**Historical Architectural Review Board  
COA Final Review Sheet**

**HDC-2023-00048**

**Address: 205 N. 9<sup>th</sup> Street**

**Proposal: Legalize installation of carport at rear driveway; replace porch floorboards**

Rear of 205 N. 9<sup>th</sup> Street showing the canopy, 2023.  
(Google StreetView)

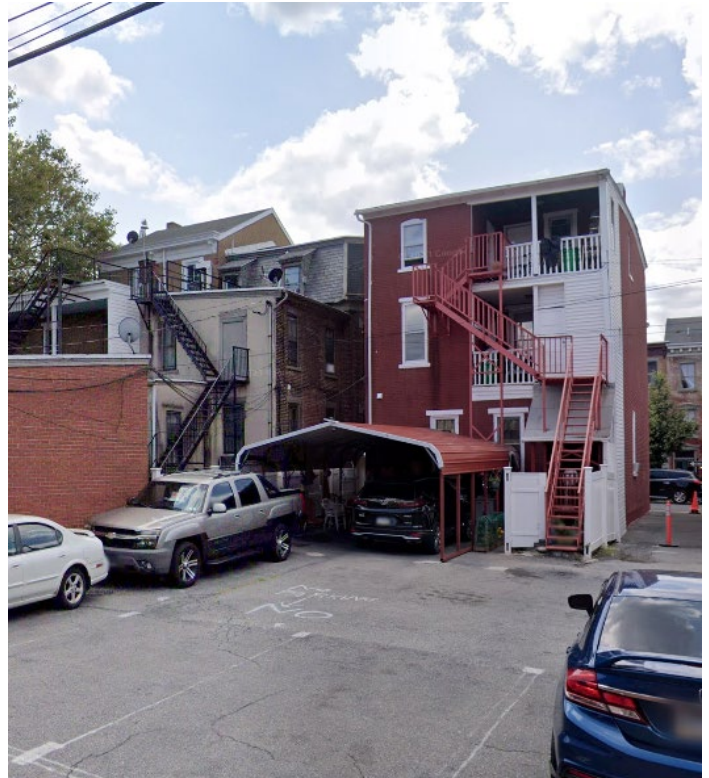
The owner contends that a medical condition has necessitated the installation of a carport to eliminate the need to remove snow and to avoid slippery conditions around his car. The structure is located immediately behind the building and is highly visible from Nagle Street, a service alley at the rear of the property. The carport has a metal roof, stands approximately six feet in height, and is open at the sides.

Staff comments that the carport meets some but not all of the guidelines in Section 5.2 New Accessory Buildings. The structure meets the guidelines for its height, massing, size, and scale, but does not comply with the guidelines related to proportion, materials, detailing, and fenestration. Staff notes that the carport is defined in the ordinance as a structure but not as a building. Because the carport is not defined as a building and is easily reversible, staff argues that it should be generally compatible with the district but may not need to meet the specific requirements and details of a typical accessory building, such as a garage. Staff contends that the structure does not have an adverse impact on the district, since it is reversible and located on a service alley.

Mr. Franzone questioned whether the carport was impeding any egress and whether it is anchored to the ground to prevent uplift. Mr. Castro replied that the carport does not prevent any access to or from the building and that it is currently anchored to the ground but can be moved. The board discussed the need for the applicant to obtain building and zoning permits.

Mr. Lichtenwalner commented that he understands the arguments that the owner needs the carport for medical reasons and added that he does not feel strongly that it needs to be removed. He opined that the structure is at the rear of the building and questioned whether it is detrimental to the neighborhood.

Mr. Huber commented that similar past applications have been denied because the structures do not respect the historic building or neighborhood. He stated that wood structures with flat shed roofs resembling the construction of garages have been permitted, because they are more appropriate and more complementary to the district.

- The carport must receive zoning approval;
- The carport must be appropriately secured to the ground to prevent uplift;
- The porch floorboards may be composite and of a red, gray, tan, white, or similar color; and
- The floorboards should be installed according to the manufacturer's specifications without altering the porch posts or railings.

Proposed porch floorboards.  
(Applicant)

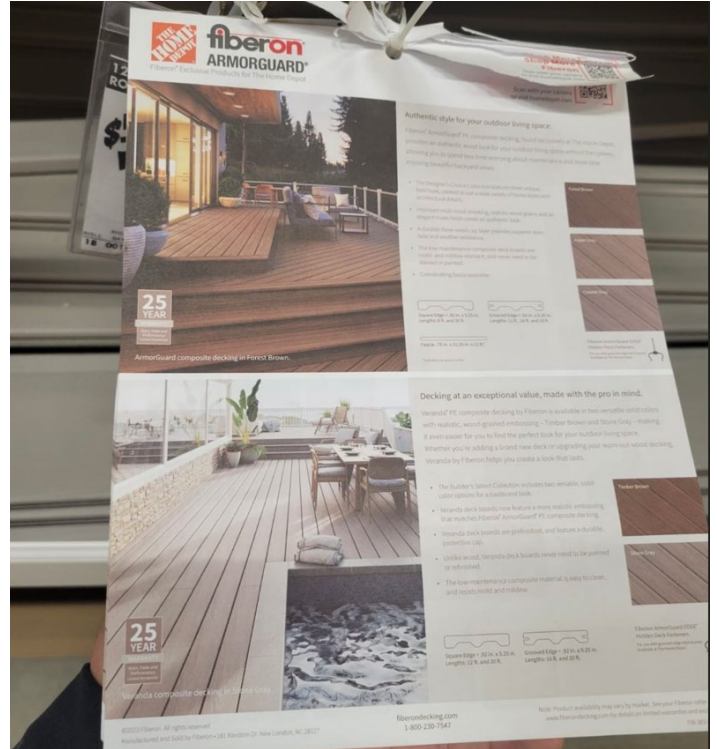
For the floorboard replacement at the front porch, staff notes that Guideline 3.7.8 allows for composite wood decking, provided the boards are similar to the original dimensions. Staff questions whether the proposed decking matches the dimensions of the historic floorboards and recommends a product that replicates the tongue and groove construction and dimensions more closely.

Regarding the front porch, Mr. Huber stated that the proposed material is decking but that a porch floorboard with solid nosing should be used. He added that the HARB regulates integral color and would need to know what color is being used. The applicant responded that he would like to use red. Mr. Lichtenwalner stated that red, gray, or grayish-tan would be appropriate.

The HARB discussed the how the floorboards would be installed around the columns and fencing. Mr. Franzone advised against cutting out the floorboards below the columns and that the new material be installed according to manufacturer's specifications.

Approval, provided tongue and groove floorboards of an appropriate size are used at the front porch, with the staff to review details, pursuant to Chapter 3, Section 3.7 Porches & Steps and Chapter 5, Section 5.2 New Accessory Buildings.
